FIELD SERVICE BULLETIN

FSB Number: LVCCFSB2006-33
Authors: Darwin Garcia
Date: February 14, 2006
Total No. of Pages: 2
Subject: **V3i CLI Low Contrast**
Model Affected: **V3i**
Level of Repair: 2

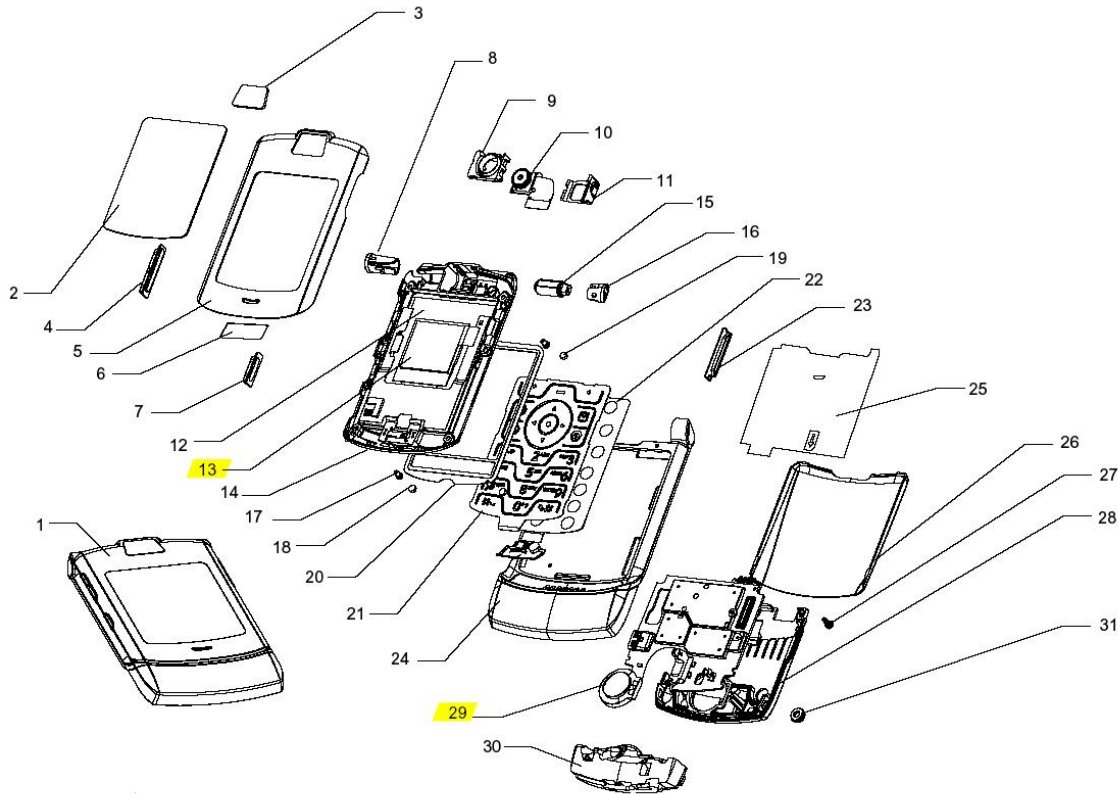
Service has been made aware of a V3i CLI low contrast issue causing “Display Secondary - Low / Dim Backlight” complaints.

Initial analysis determined that the Vout line voltage on the CLI that controls the contrast level was below the desire value of +10.5V, this line is control by the setting on the OTP Registry.

When servicing any V3i customer phones with described complaint, measure the voltage level on TP1 to determine if it is below +10.5V, if it is replace the display module (Part Number 12= 7271302B01).
